**UNITED STATES
NUCLEAR REGULATORY COMMISSION**
WASHINGTON, D.C. 20555-0001

**SUBJECT: MONTICELLO NUCLEAR GENERATING PLANT– SAFETY EVALUATION
REGARDING IMPLEMENTATION OF MITIGATING STRATEGIES AND
RELIABLE SPENT FUEL POOL INSTRUMENTATION RELATED TO ORDERS
EA-12-049 AND EA-12-051 (CAC NOS. MF0923 AND MF0924; EPID NOS.
L-2013-JLD-0015 AND L-2013-JLD-0016)**

MONTICELLO NUCLEAR GENERATING PLANT

In the licensee's letter dated February 20, 2017, a sketch was provided depicting the SFP levels of monitoring. The sketch was titled "Figure 1-1 - Spent Fuel Pool Levels (Revised)," and is reproduced below:

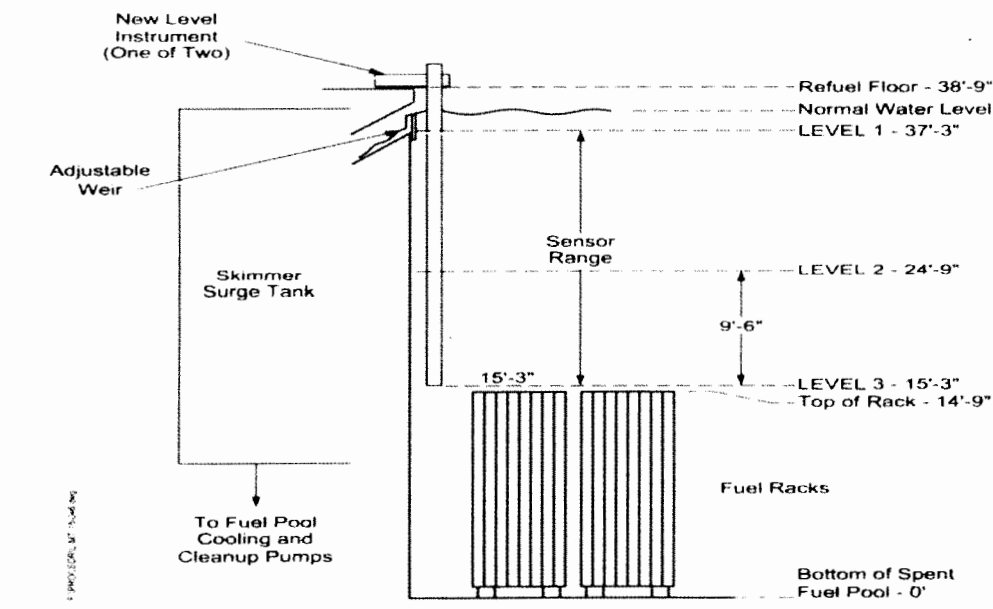
The staff performed an onsite audit to review the implementation of SFP level instrumentation related to Order EA-12-051 at Monticello. The scope of the audit included verification of whether the: (a) site's seismic and environmental conditions are enveloped by the equipment qualifications, (b) equipment installation met the order requirements and vendor's recommendations, and (c) program features met the order requirements. By letter dated March 17, 2015 [Reference 22], the NRC issued an audit report on the licensee's progress.
